# M.A.F. & Associates, LLC

RE: Marley Park Beach. Lots 33-37, Block K  
408 Summit Avenue, Glen Burnie, MD 21060

Prefile comments:

### CONFIRMATION OF PRE-FILE

**TYPICAL DRY WELL SECTION (MICRO-SCALE 'M-5' DRY WELL)**  
 NOT TO SCALE

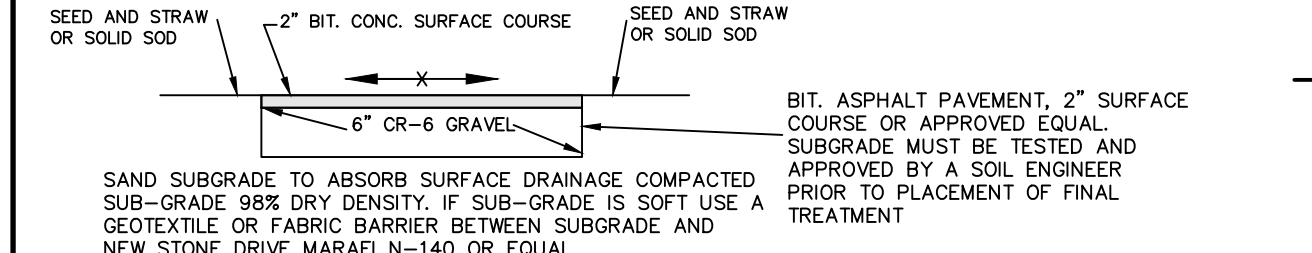
1. Please note that locating the drywell under the driveway for a residential home is not permitted. The reason for this is that in the event of failure, settlement, sinkhole, etc., the homeowner will have issues accessing and parking. While dealing with the situation, which would be problematic and a burden risk for residential homeowners.

Our response: This will be addressed with the grading permit review.

**PROPOSED CONDITIONS PLAN SCALE: 1"=20'**

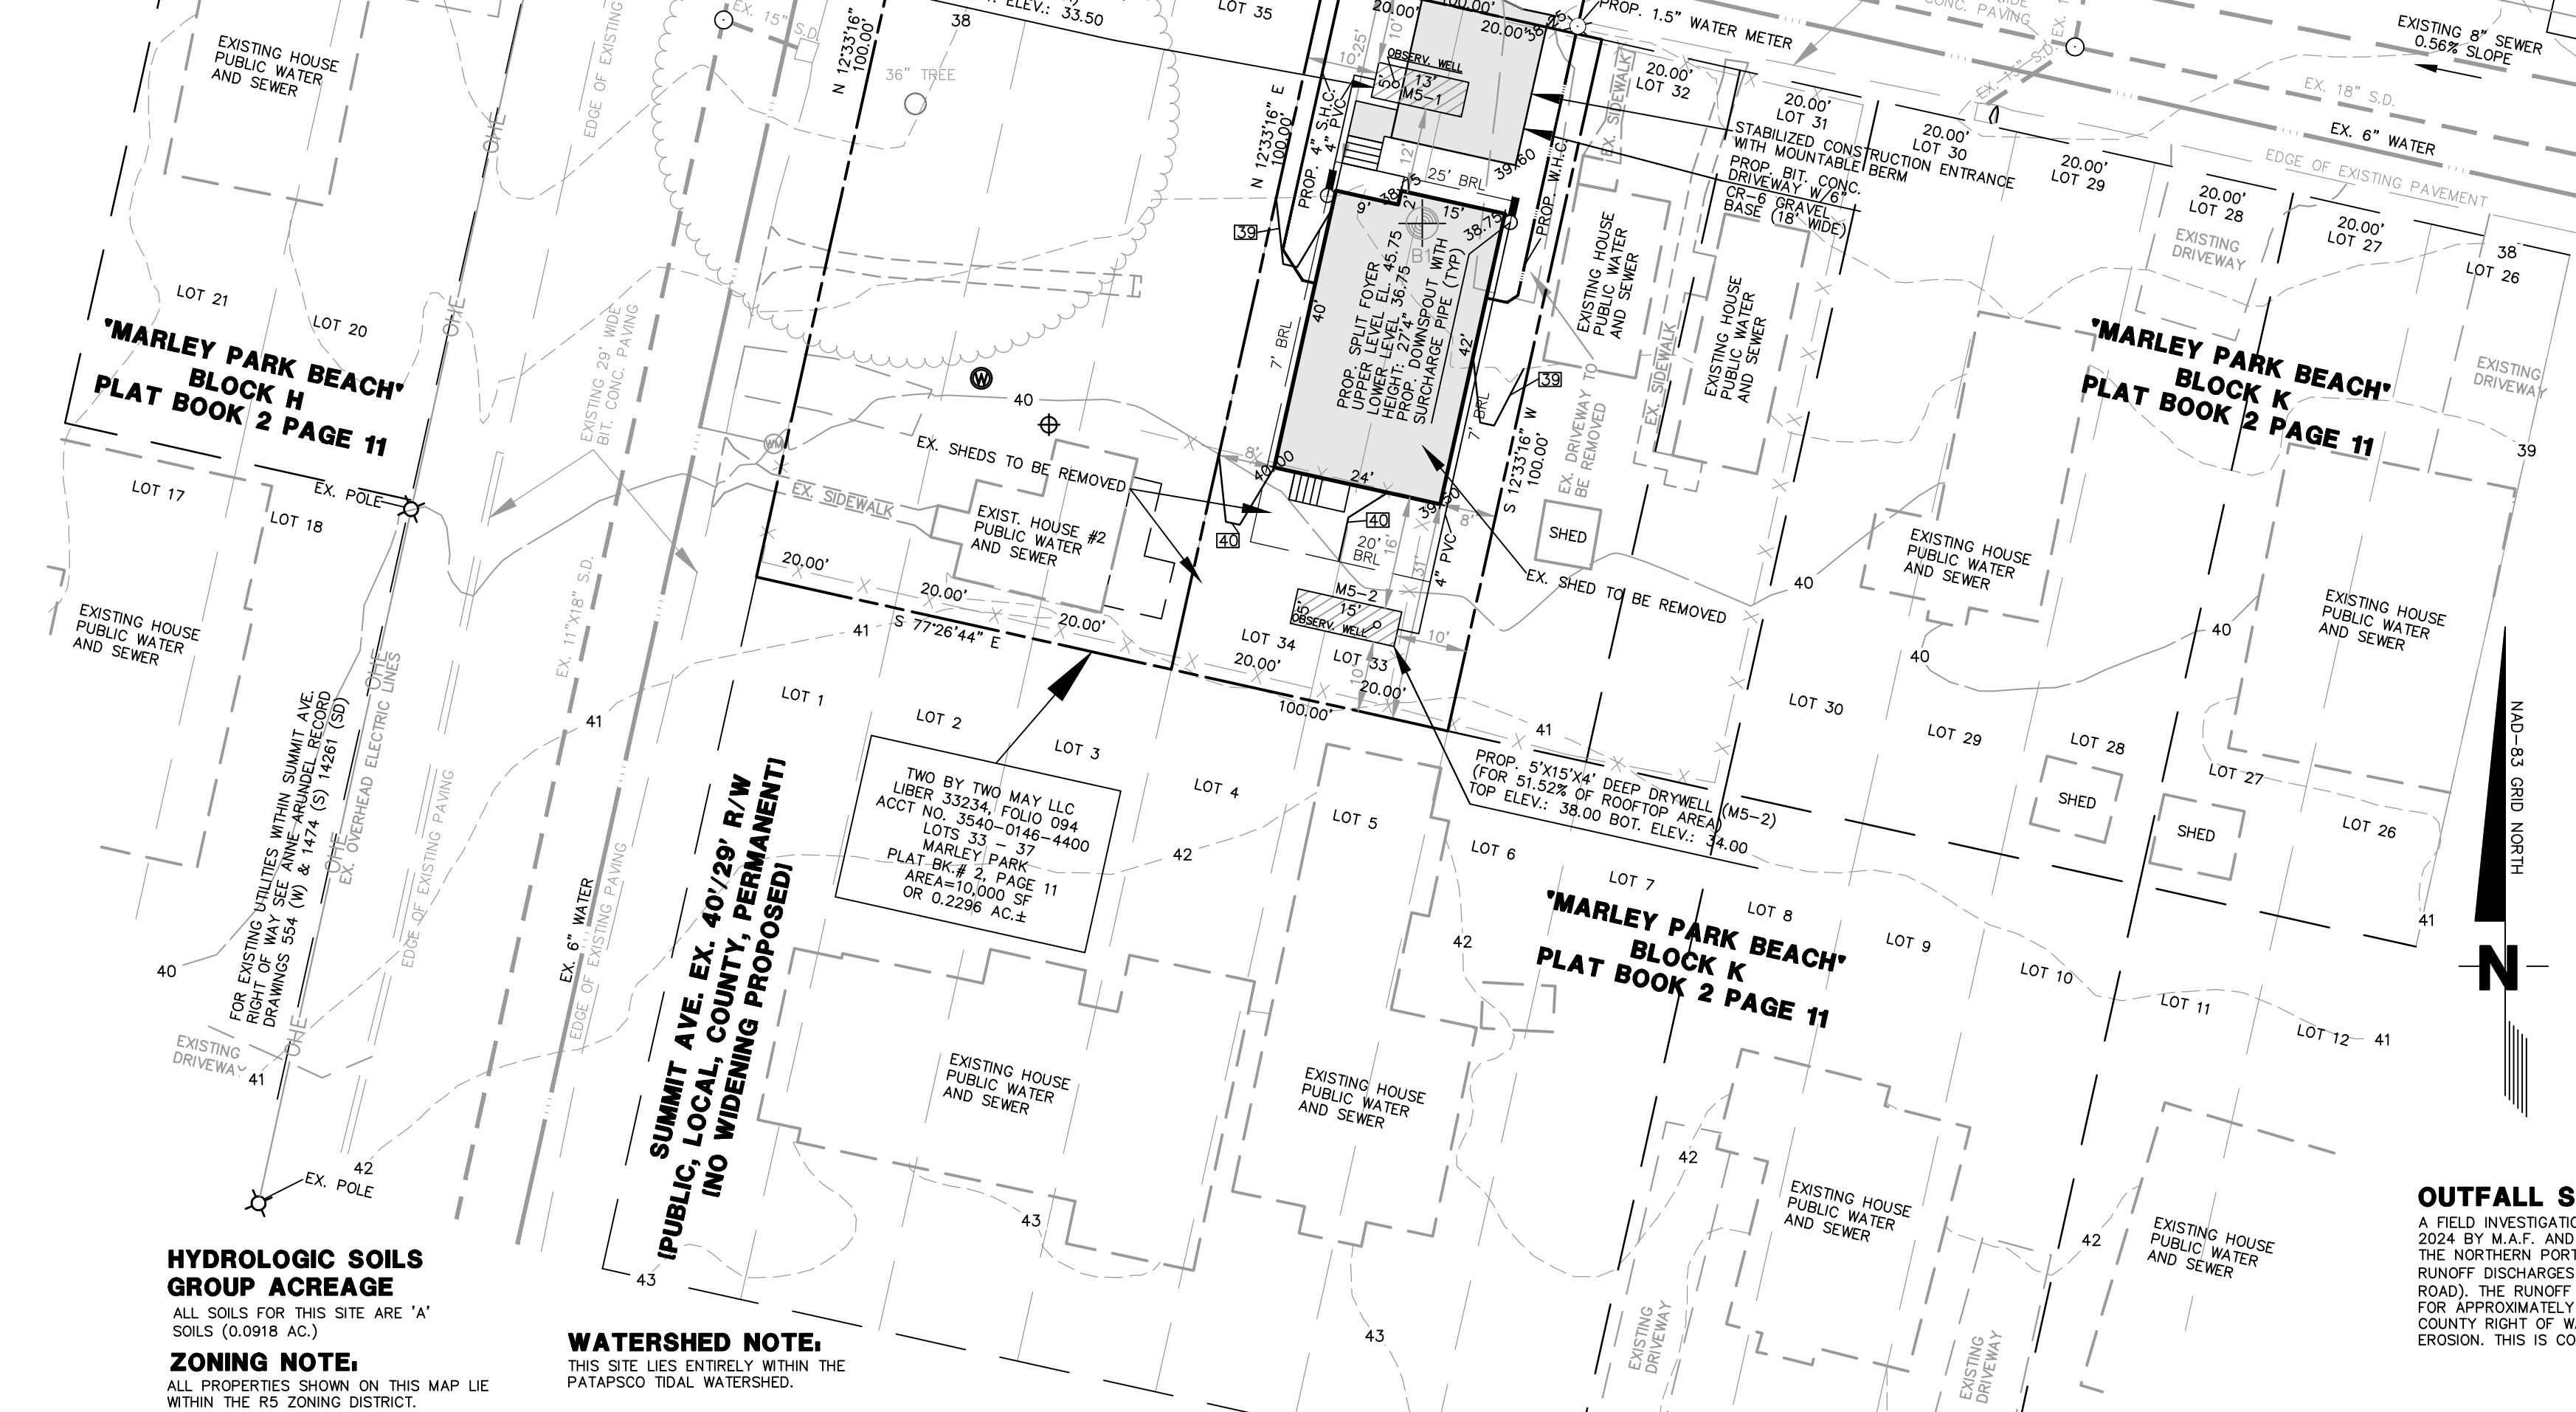
2. Identify site outfall to review the site plan and provide feedback regarding potential in impact.

Our response: The site outfall was noted on the submitted grading and sediment control plan. The outfall is at the county right of way that drains to a county closed storm drain system.
